REMARKS/ARGUMENT

APPENDIX B
Version With Markings To Show Changes Made
37 CFR 1.121(b)(iii) AND (c)(ii)

Fig. 10

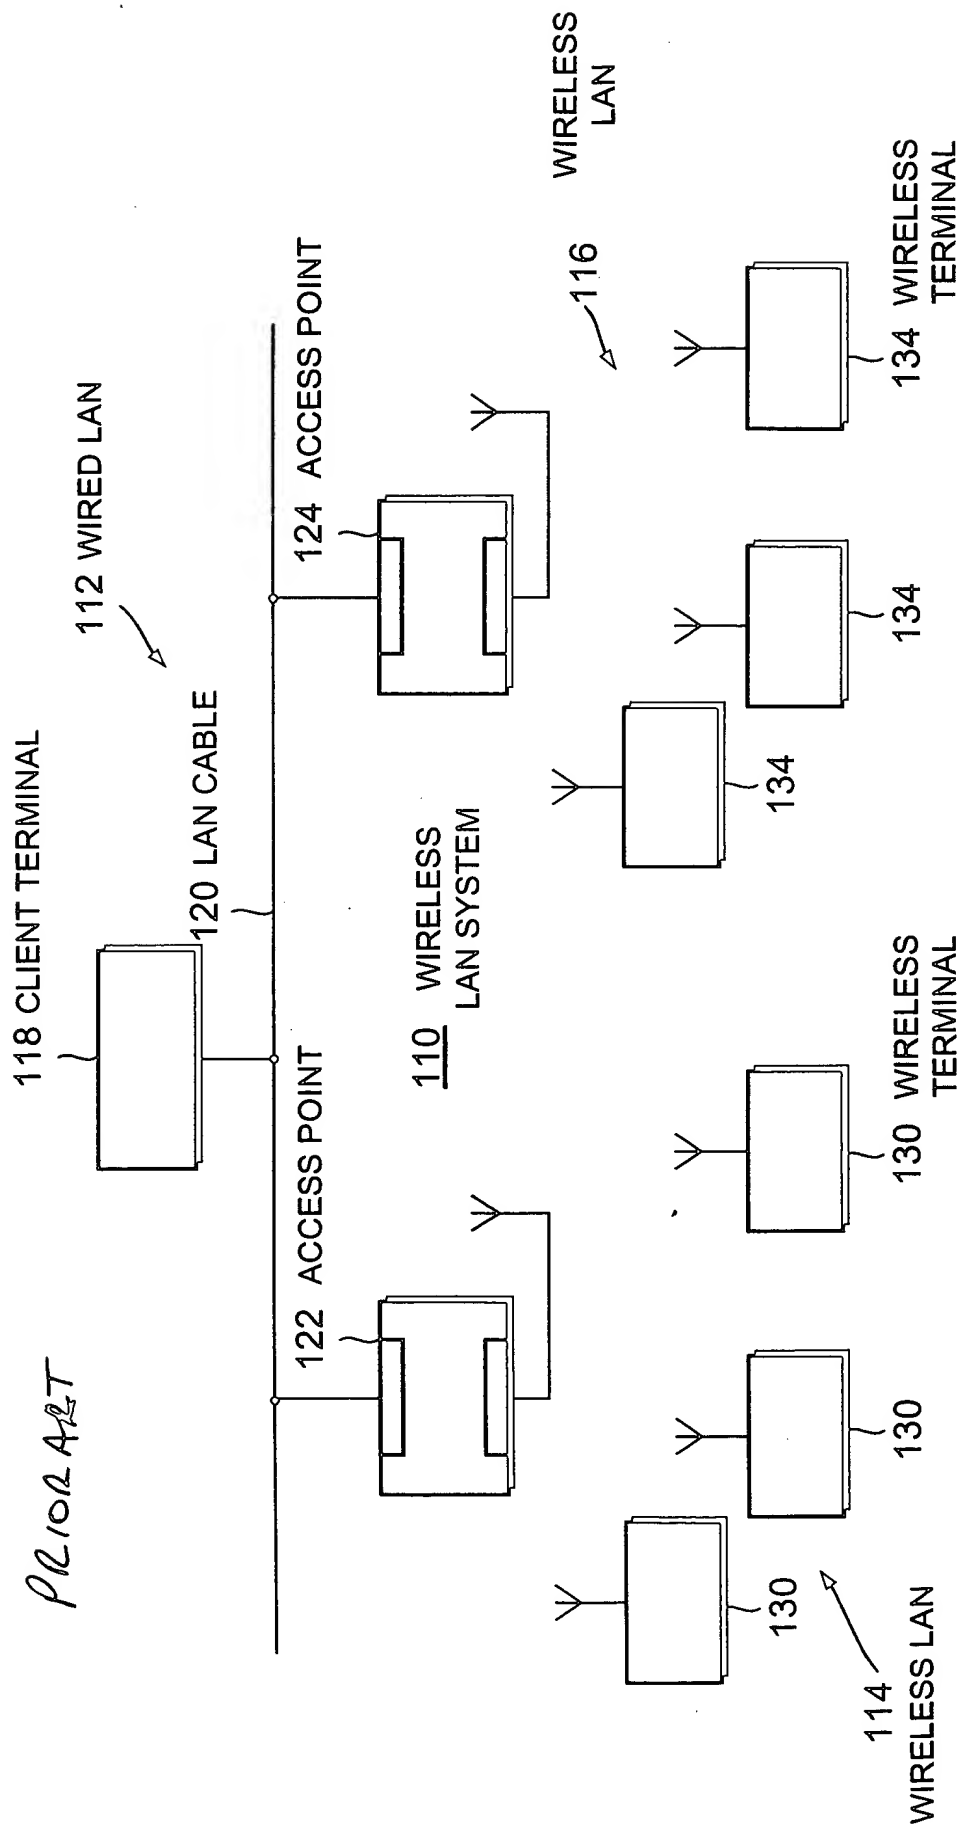
In paragraph 2 of the Office Action, Figures 10 through 14 were objected to because they are not designated by a legend as being prior art. Attached hereto are a corrected set of drawings wherein the legend “Prior Art,” written in red ink, has been appended to each of Figures 10 through 14. The Applicant respectfully requests that the objection to the drawings be withdrawn.

Corrected Formal Drawings (Figures 10 through 14) are attached for the Examiner’s convenience. Entry is respectfully requested.
